ADDENDUM NO. 2

PROJECT: NW Connell and NW Garibaldi Street Improvements, No. 10485

DATE: June 27, 2013

This addendum to the contract documents is issued to clarify, correct, and supplement the drawings and contract documents issued as "NW Connell and NW Garibaldi Street Improvements", bid closing date July 2, 2013.

SHEET NO. C-106A		DRAWING NO. 22 OF 32		PROJECT NO. 10485	
NW CONNELL AVE & NW GARIBALDI ST IMPROVEMENTS					
8TH AVE WQF PROFILE					
Hillsboro OREGON					
PHONE: 503.681.6146 FAX: 503.681.6245 150 E MAIN ST 4TH FLOOR HILLSBORO, OR 97123-4089 FILE NAME: PROPOSED ALTA.DWG					
EXPIRES: 6/30/2015

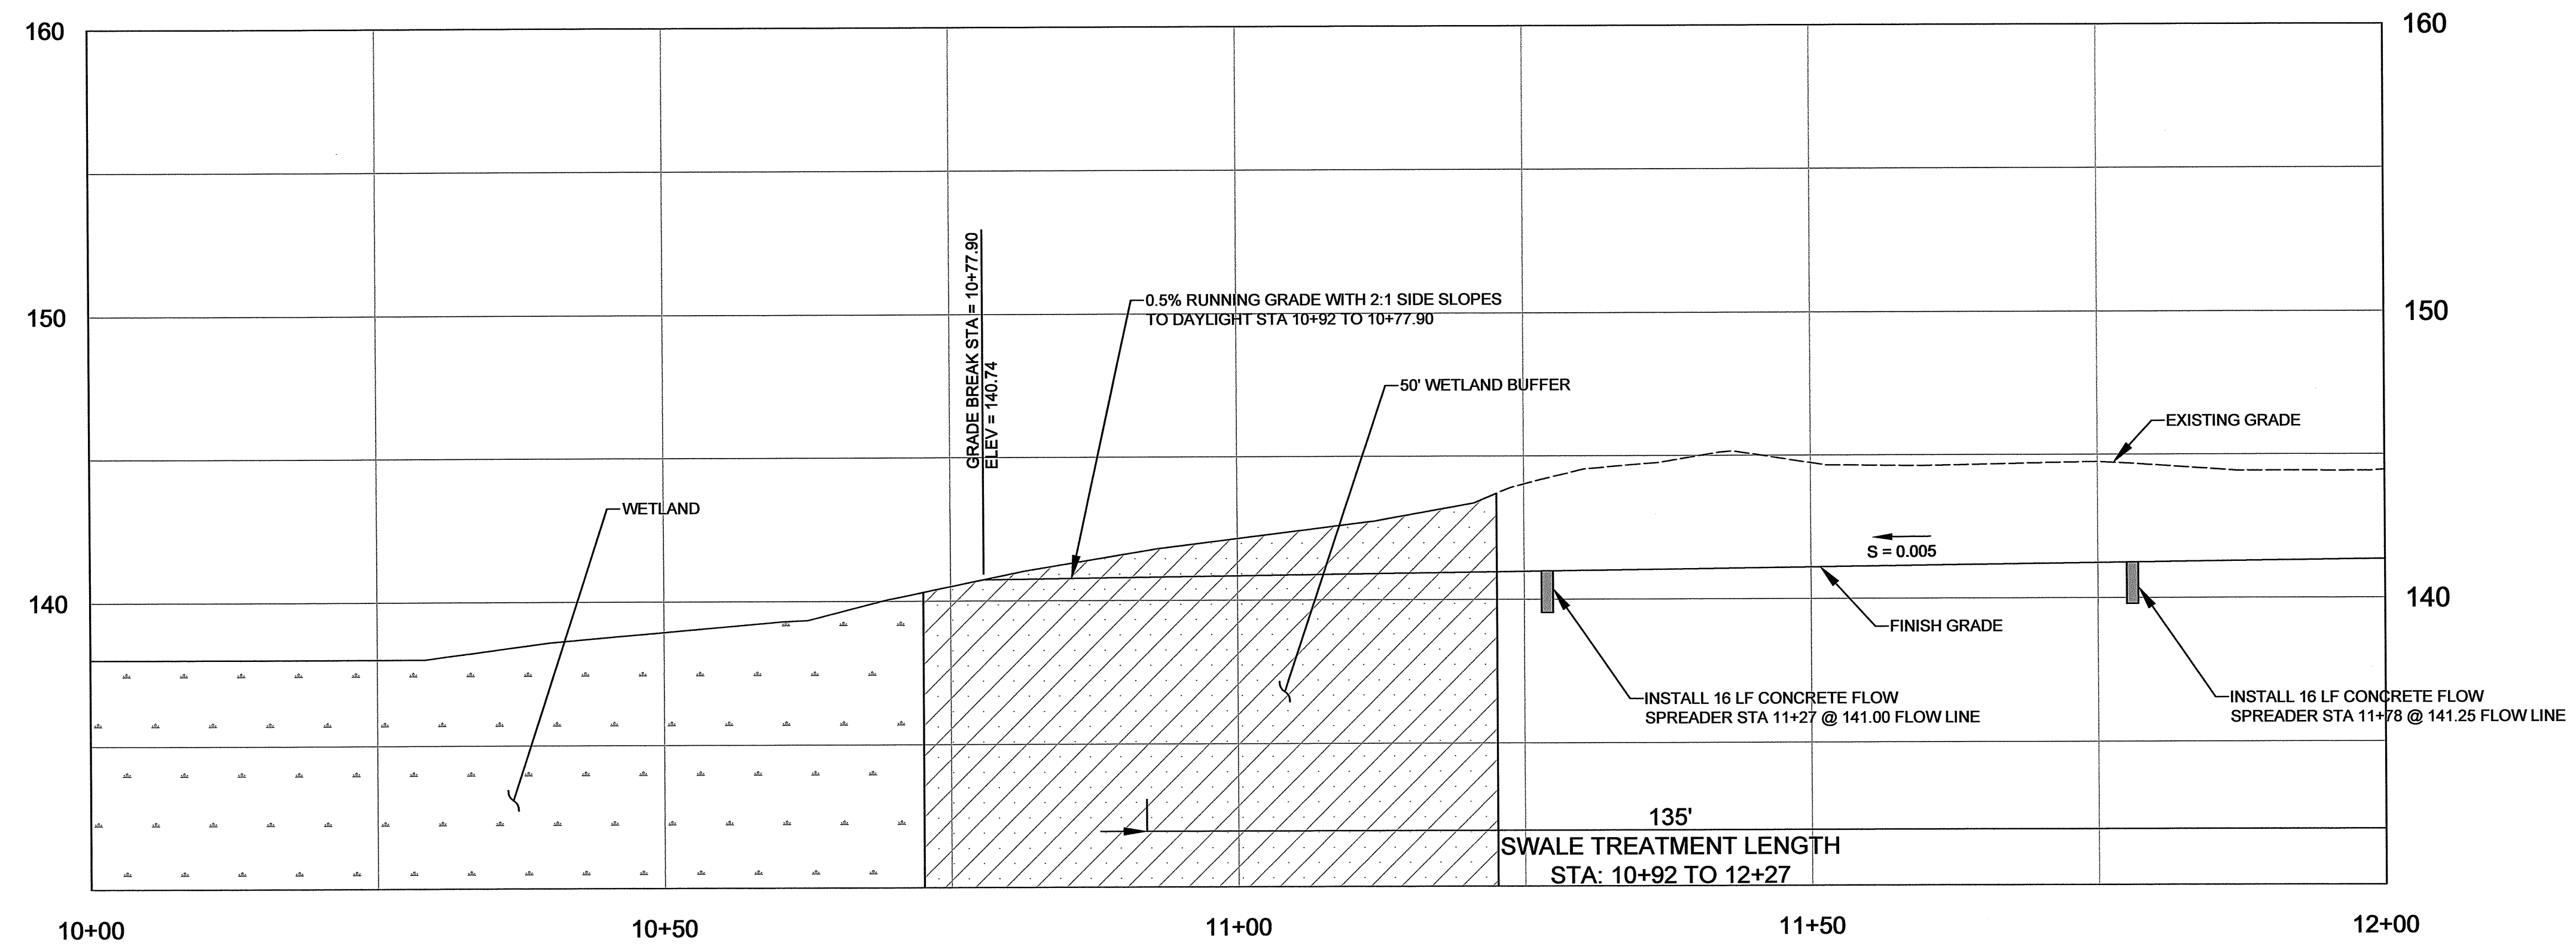
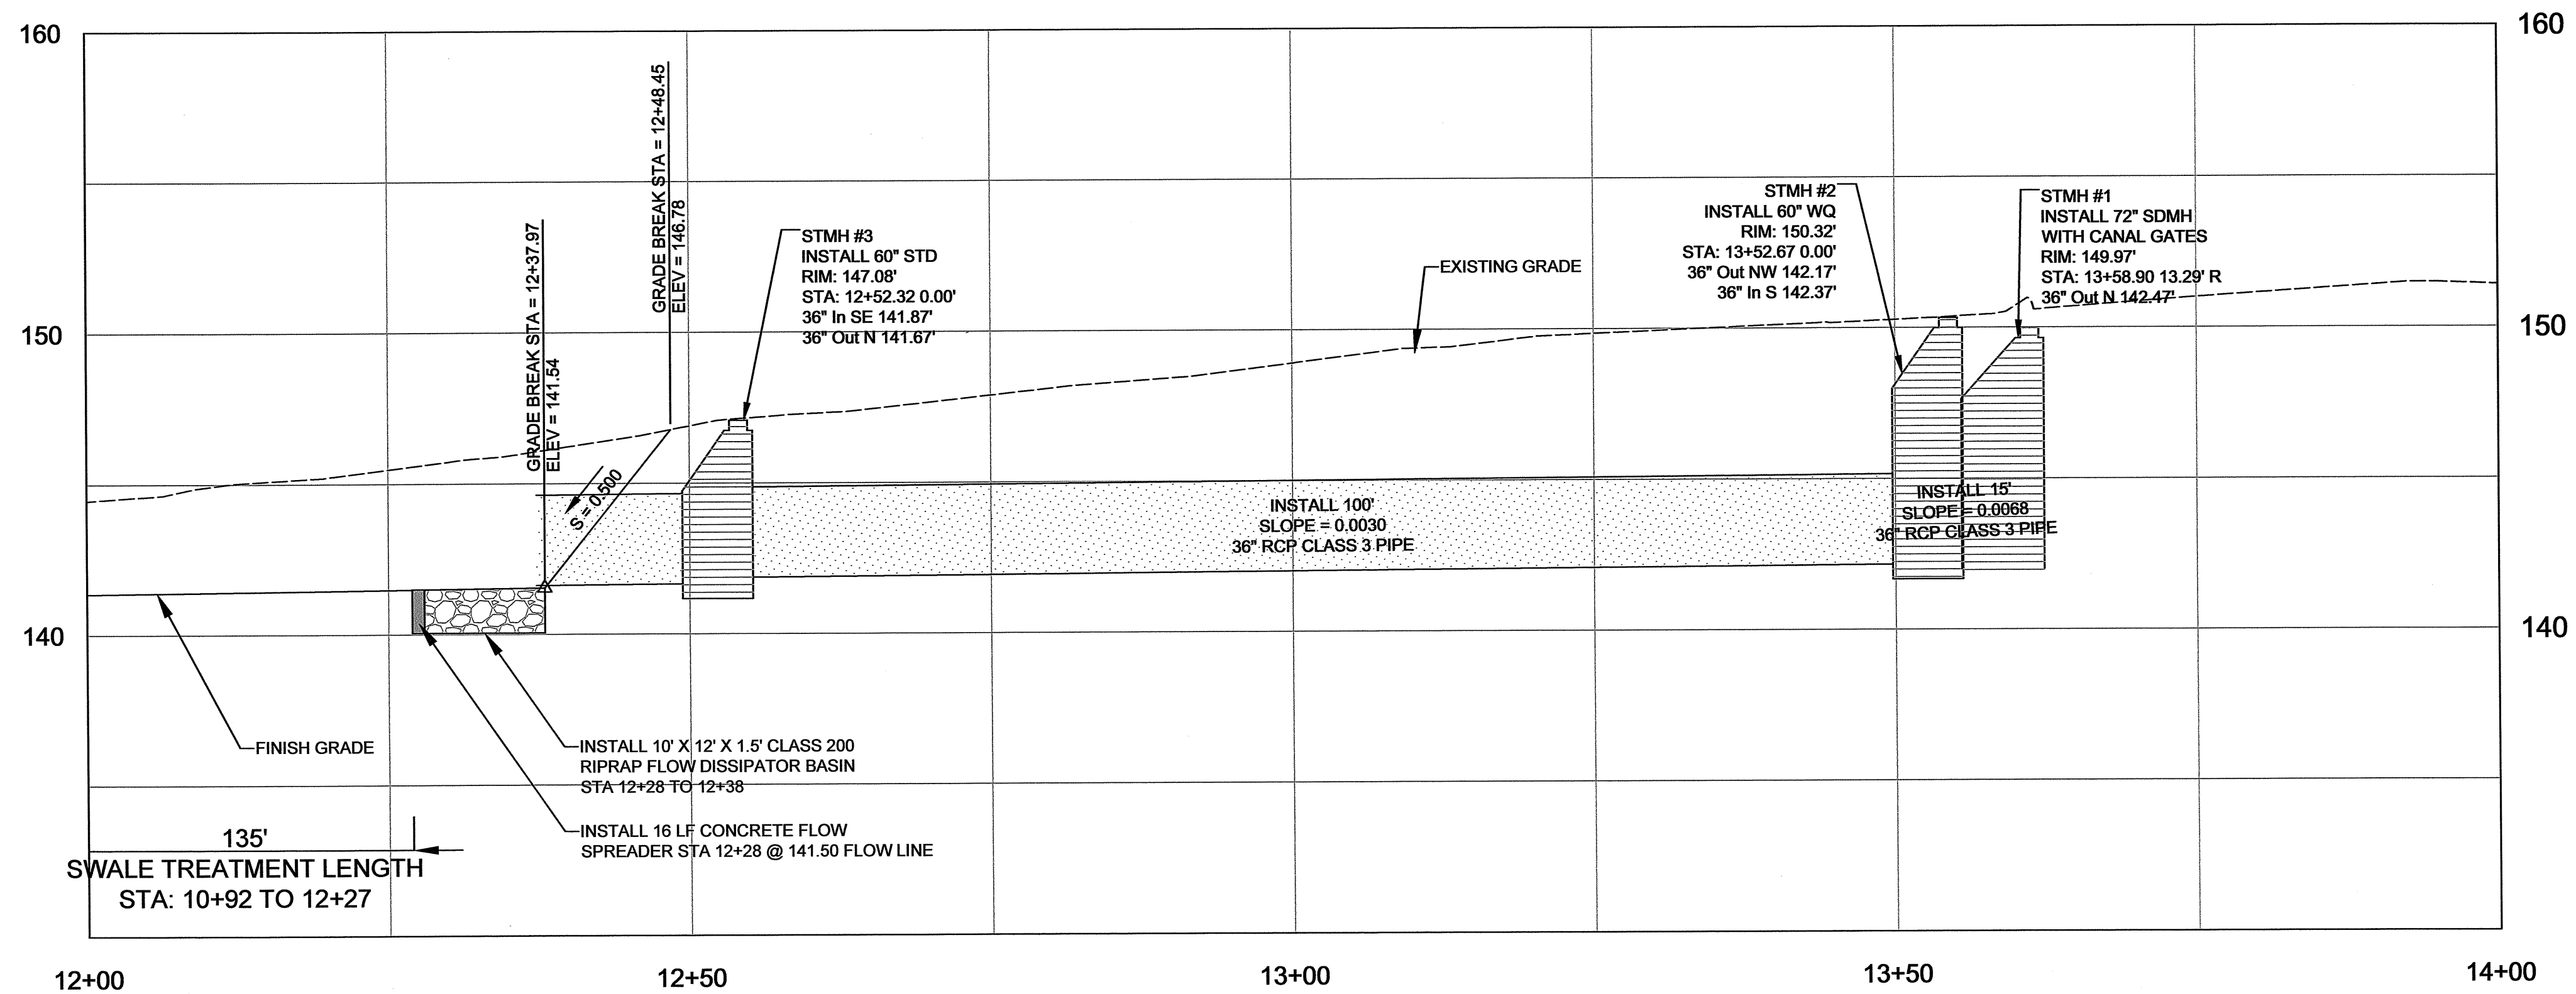
Pages C-106 and C-106A (21&22 of 32)

1. Change all 36" pipe to 36" Class 3 Concrete pipe.

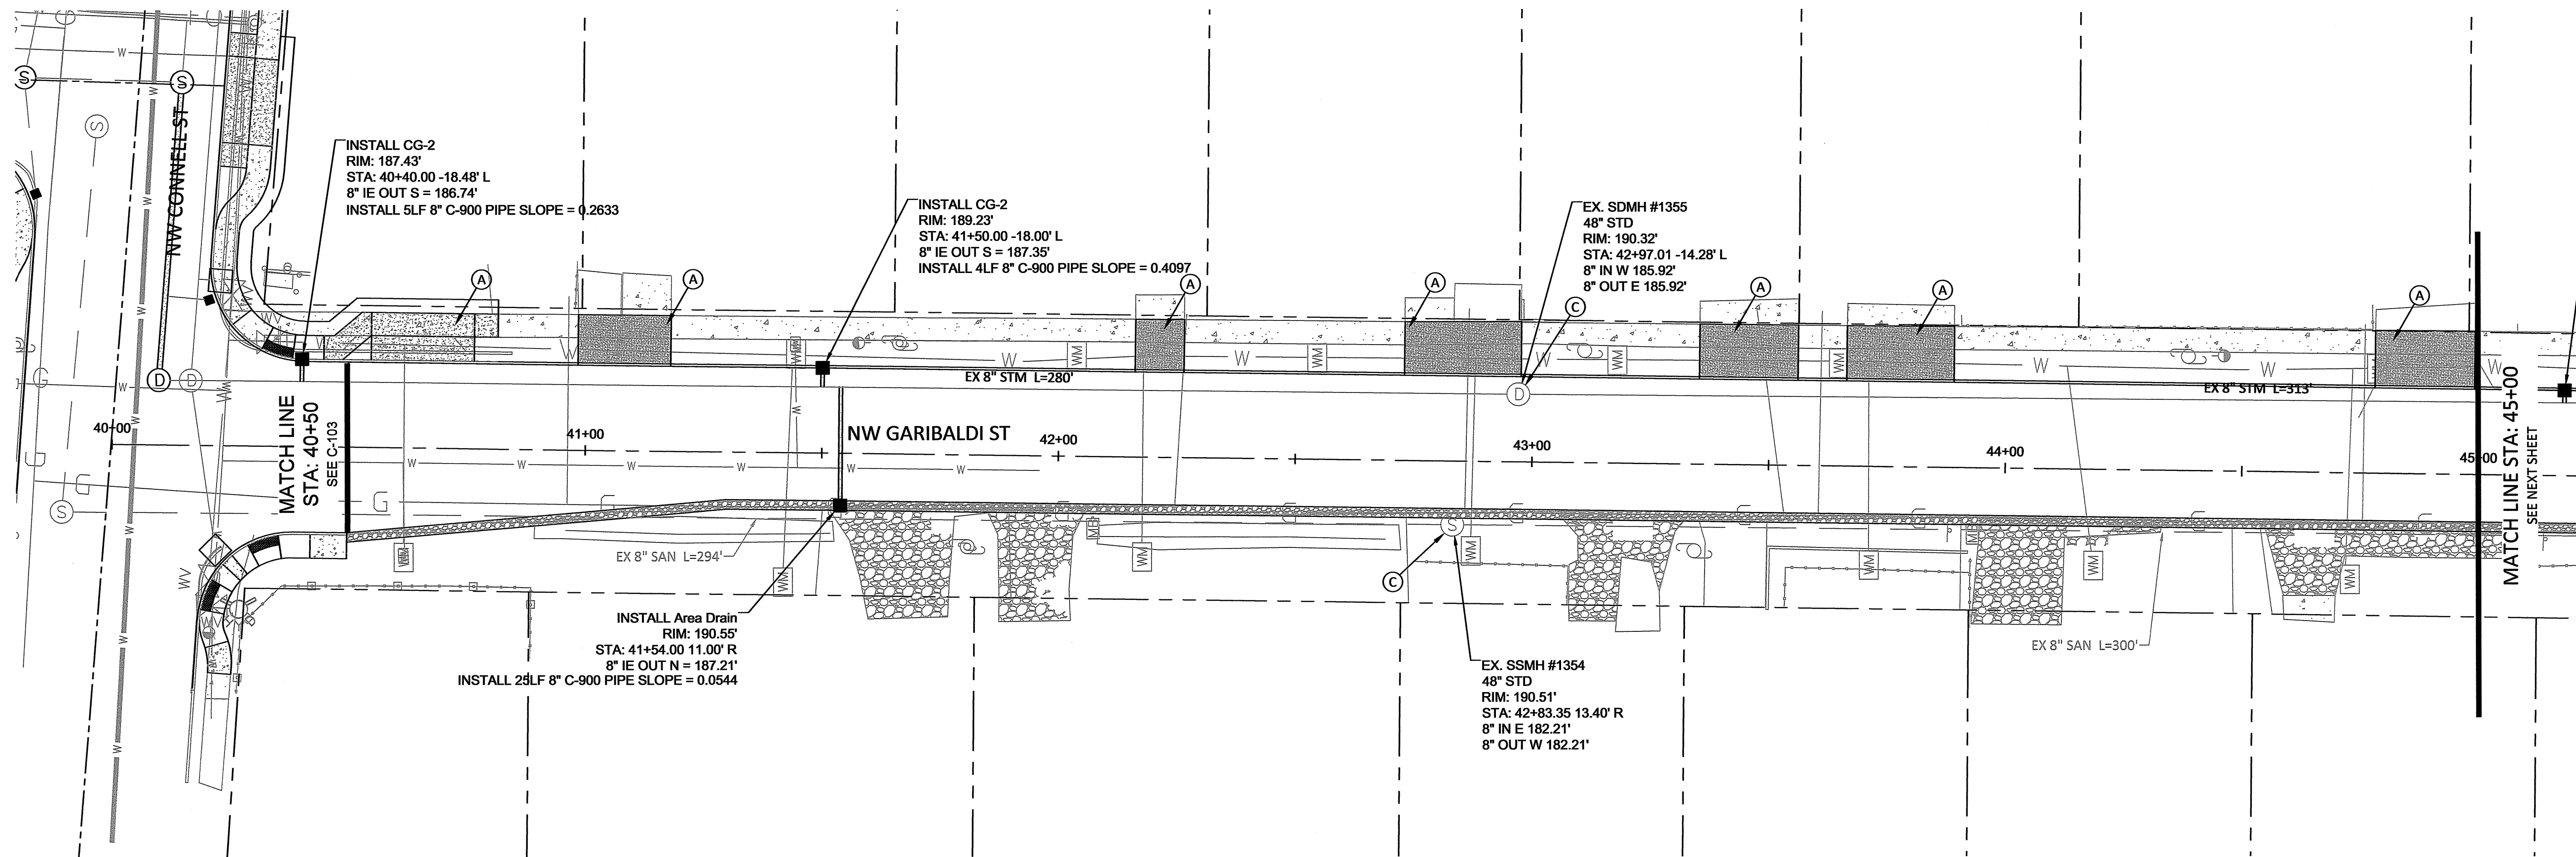
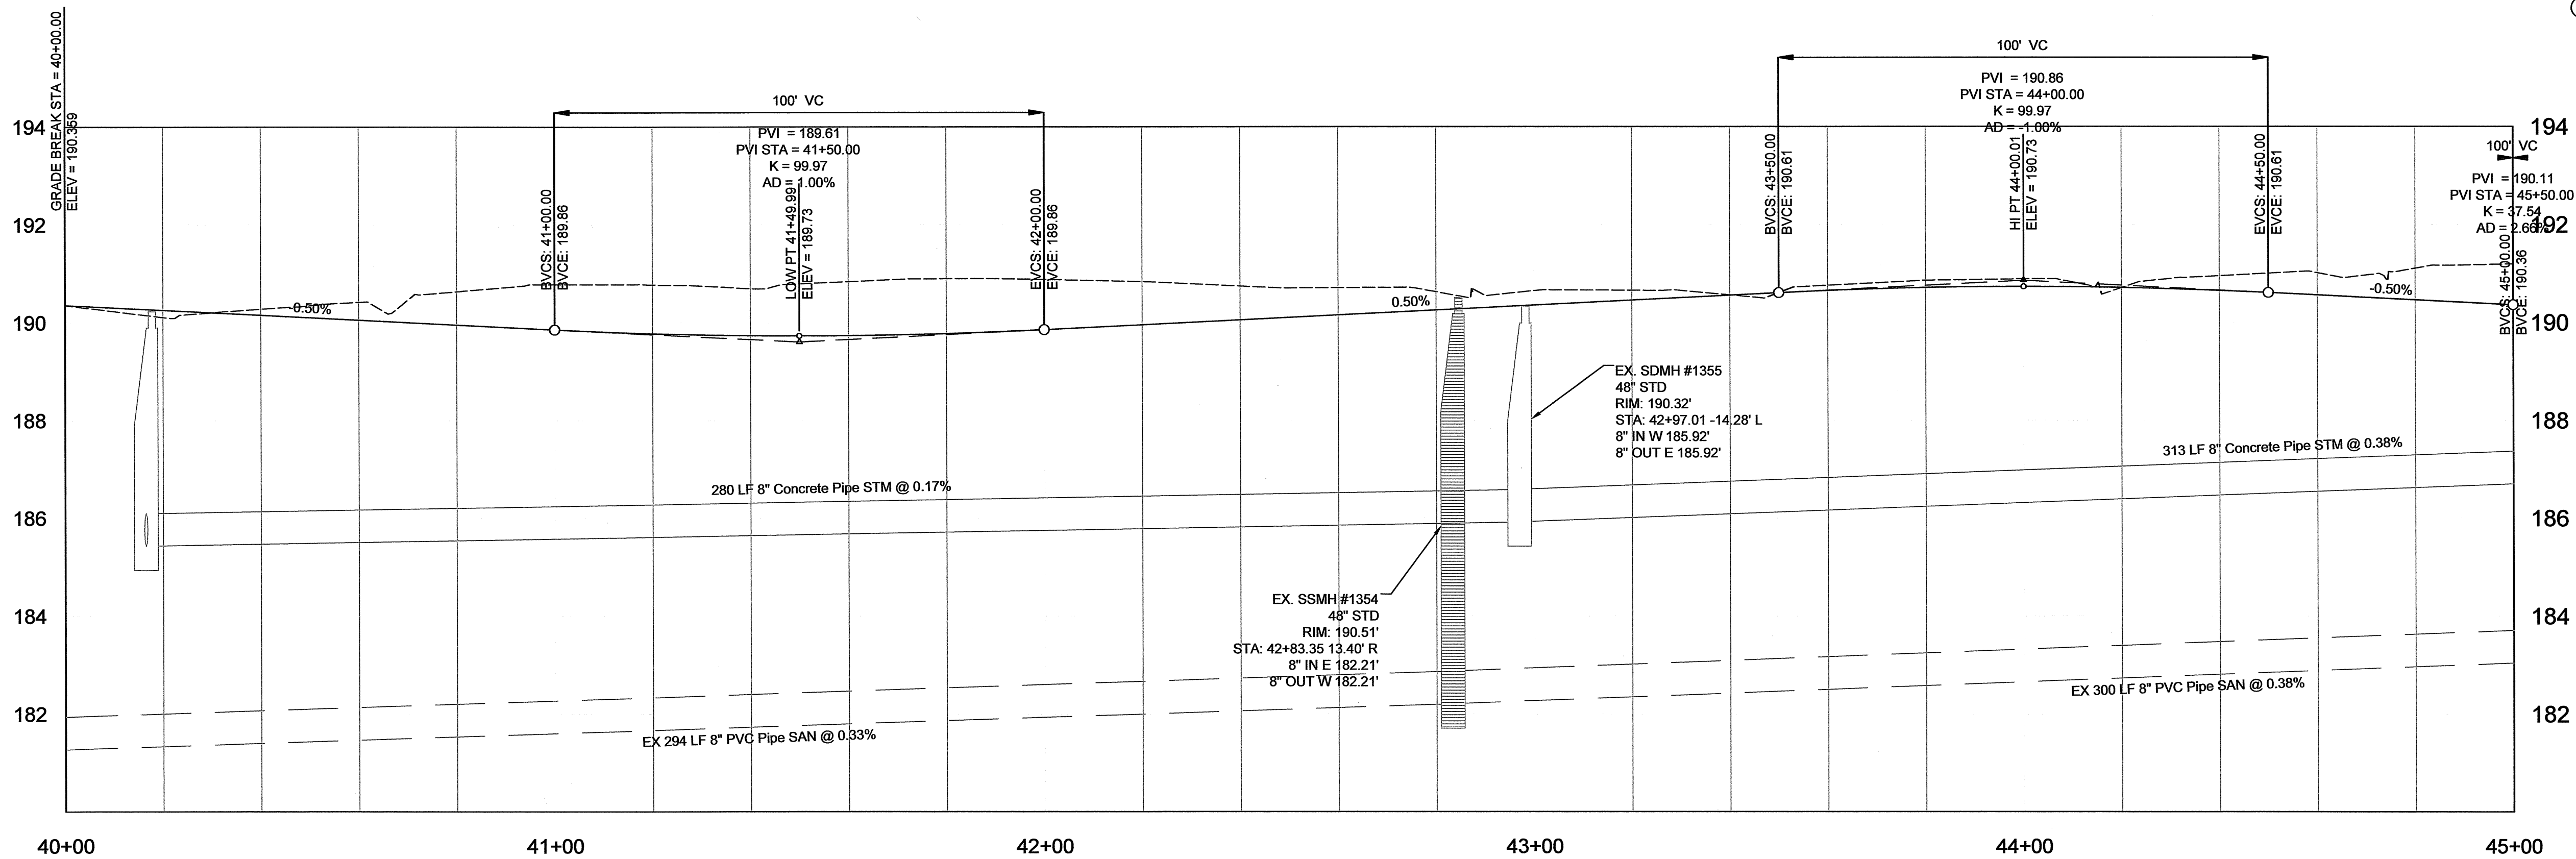
Pages C-107 and C-108 (24&25 of 32)

1. Change all CB and area drain pipe runs to 8" C-900
2. Add the following note to each CB and area drain connection(5 locations):
Cut in factory 8"x8" tee to connect CB (or area drain) to 8" storm main line
3. Add the following note the existing storm manhole at STA 46+09

Break into existing manhole and connect 8" line to existing manhole
IE = 187.32 NEW 8" IN S
IE = 187.12 8" OUT W

12a. Cut 8" factory tee into existing storm line.

Where catch basin runs and area drain runs connect to the existing 8" storm main line on sheets C-107 and C-108, it is necessary to make the connection by cutting a factory tee into the existing concrete storm line. This bid item shall include the factory tee, all necessary rigid fittings/couplers, any pipe, and all labor, excavation, and backfill necessary to fabricate a connection to the existing storm line. Incidental to this bid item shall be a TV inspection of the existing storm line to ensure all connections are sound.
